Form 3160-5  
(August 2007)

Bell Lake Unit 2 #6

Proposal to plug-back the Devonian &amp; recompleat in the Morrow:

**Bell Lake – DV #6**  
**30-025-08483**  
**Kaiser-Francis Oil Company**  
**July 12, 2011**  
**Conditions of Approval**

## NORTH BELL LAKE #2-6

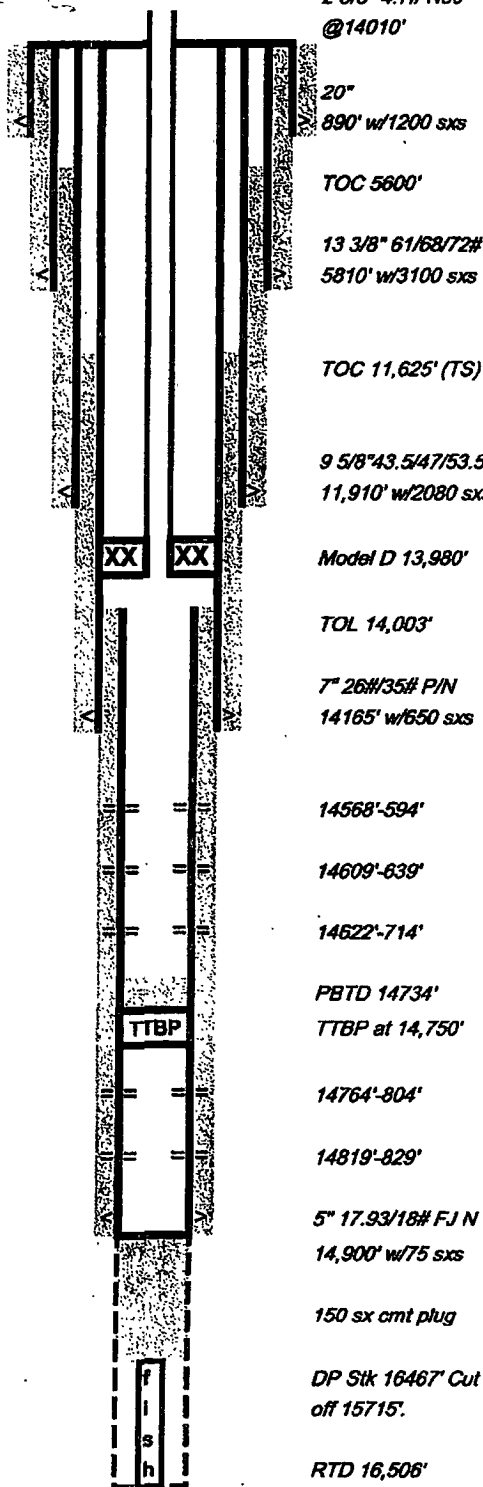
1. Contact BLM 575-393-3612 (Lea County) or 575-361-2822 (Eddy County) a minimum of 4 hours prior to setting CIBP above the Devonian.
2. The packer needs to be pulled or drilled out to properly plugback the Devonian. A plug must be set across the upper Devonian perms, the 7" casing shoe and the 5" liner. Set CIBP above the perms, tag, and dump at least 35' of cement on top. Then set a plug 50' below the shoe and 50' above the 5" liner (14215'-13950'). WOC and tag.

3. If perms for 3<sup>rd</sup> and 4<sup>th</sup> Morrow are non-commercial, the CIBP needs to have at least 35' of cement if bailed or a minimum of 25 sx if pumped.
